July 12, 2011

**Re: Pioneer Valley Energy Center, Westfield, Massachusetts
Prevention of Significant Deterioration Air Permit Application
Information Request Response
ESS Project Number E402-007.01**

Figure 1A

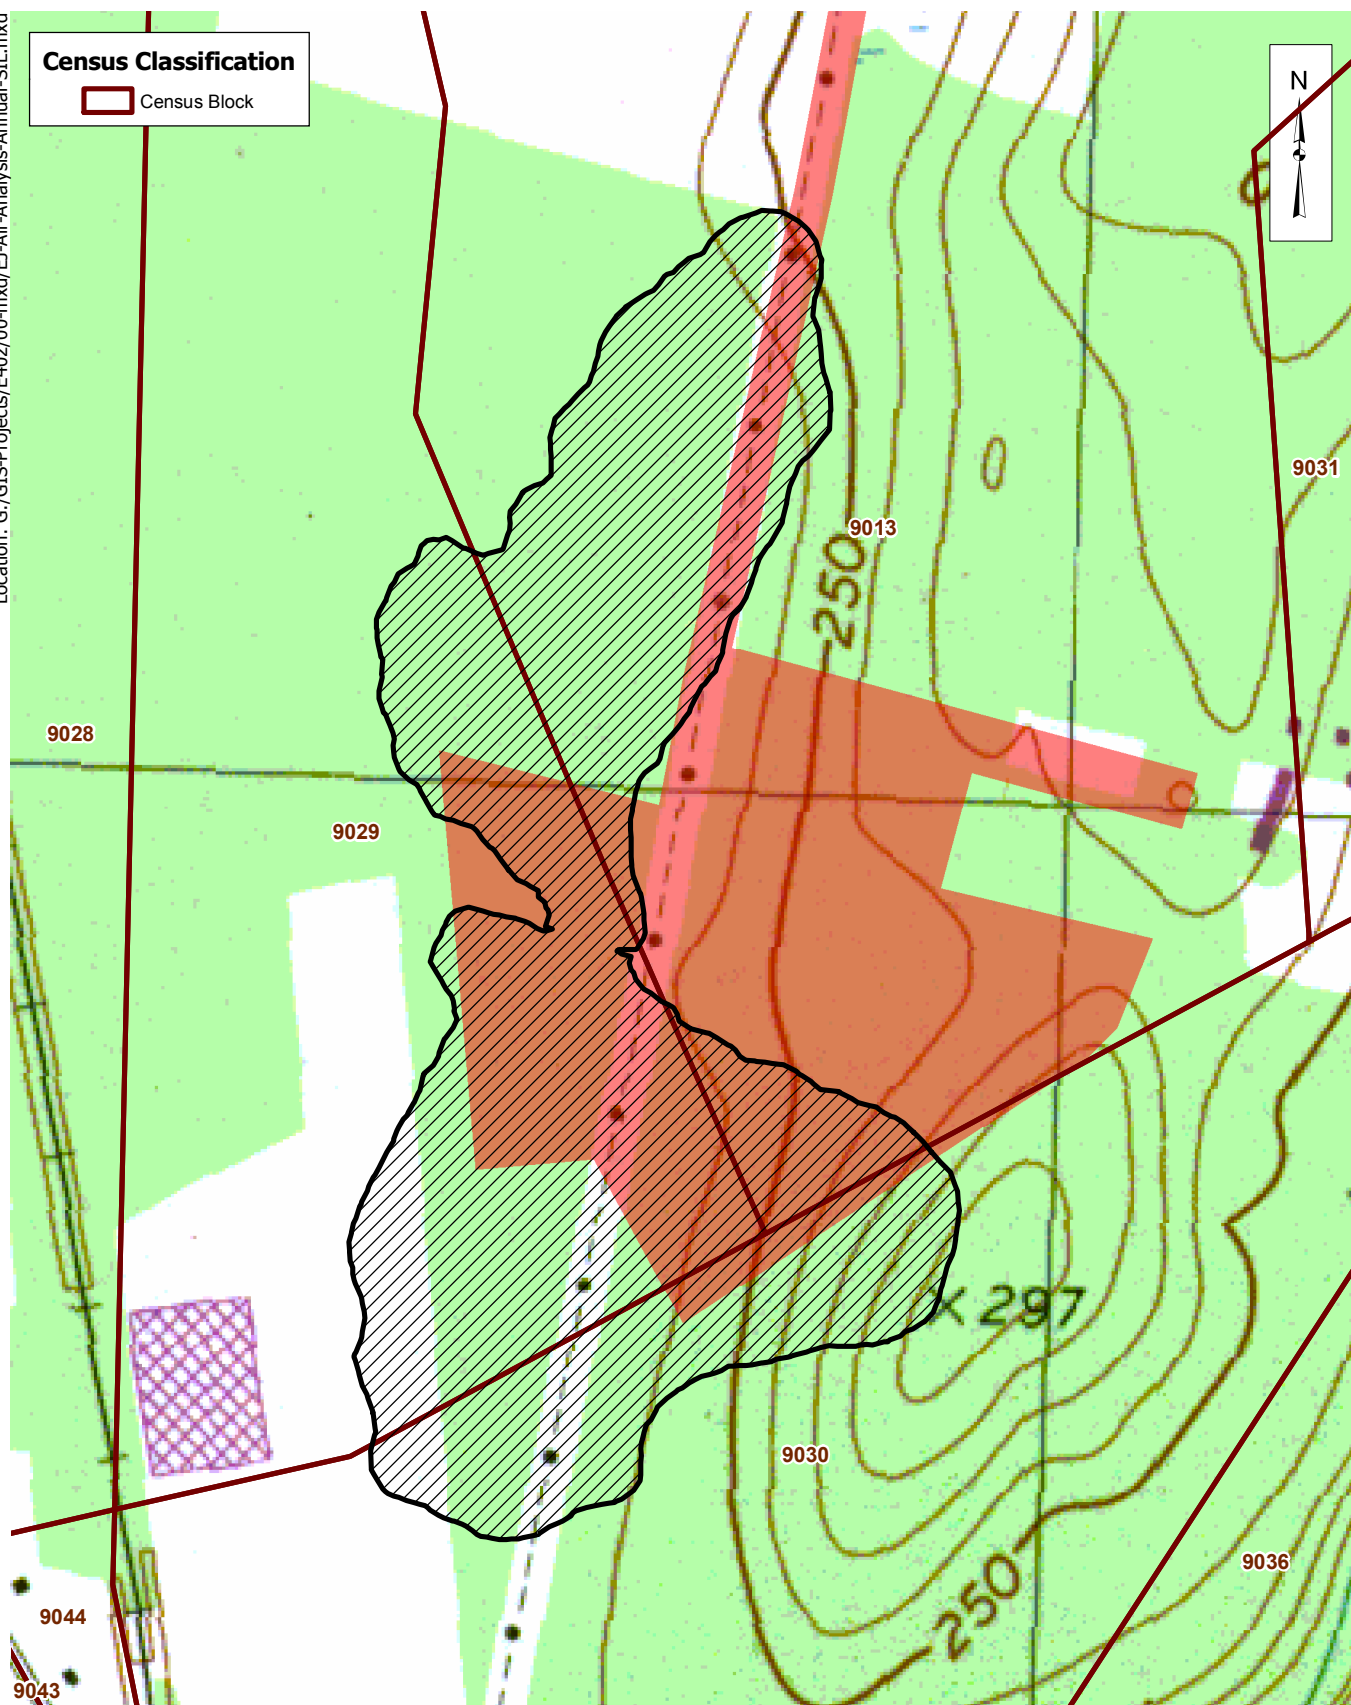
1. The EPA has requested that PVEC provide figures which magnify the significant impact areas (SIA) for annual and 24-hour $PM_{2.5}$. The attached figures (Figures 1A and 2A) provide such detail. As shown on Figures 1A and 2A, neither the SIA for annual nor 24-hour $PM_{2.5}$ include any identified environmental justice areas.
